SAFETY ALERT

Product Safety Bulletin No. 8

650 Ton Top Drive

The current configuration showing the location of hydraulic manifold assembly (A100181) on lower well control valve actuator.

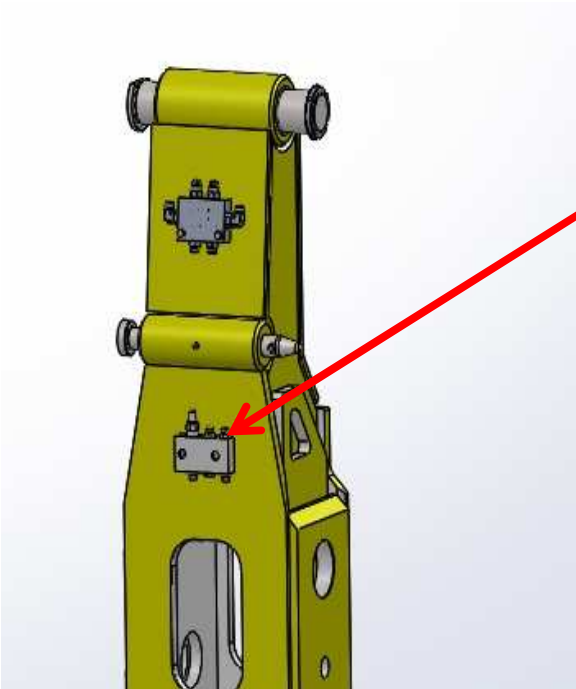
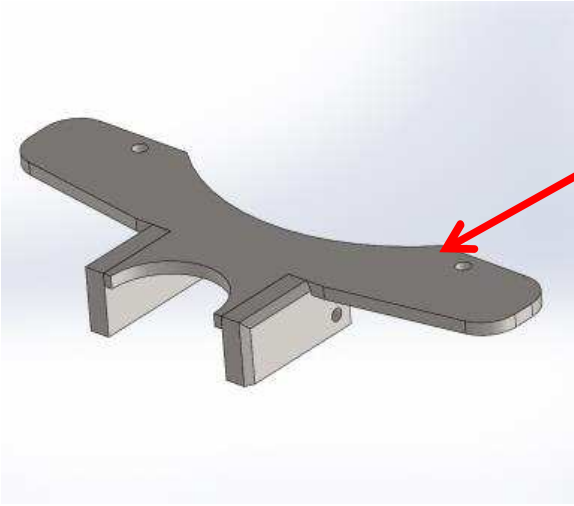
It has also been observed that the hydraulic manifold mounted on the lower well control valve actuator could come into contact with the torque arrestor.

During periods of rough drilling, it has been observed that the anti-rotation device could slide together and allow the valve mounted on the actuator to contact with the BUW wrench weldment and cause wear to the valve body.

GDS recommends inspecting the hydraulic manifold assembly for possible damage and relocating it to the BUW weldment assembly.

The new configuration showing the valve relocated to the BUW weldment using relocation kit (GDS P/N A600019).

Part M500748, anti-rotation weldment, is available as a part of A600012 rev 02 kits.

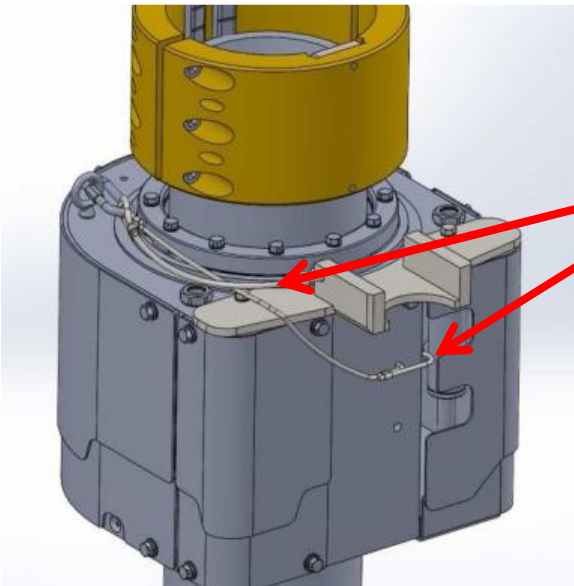
Safety cable to anti-rotation weldment.

Safety cable added to actuator slide

GDS further recommends replacing the current anti-rotation assembly with A600012 rev. 02, which will better allow for movement during any rough drilling period.
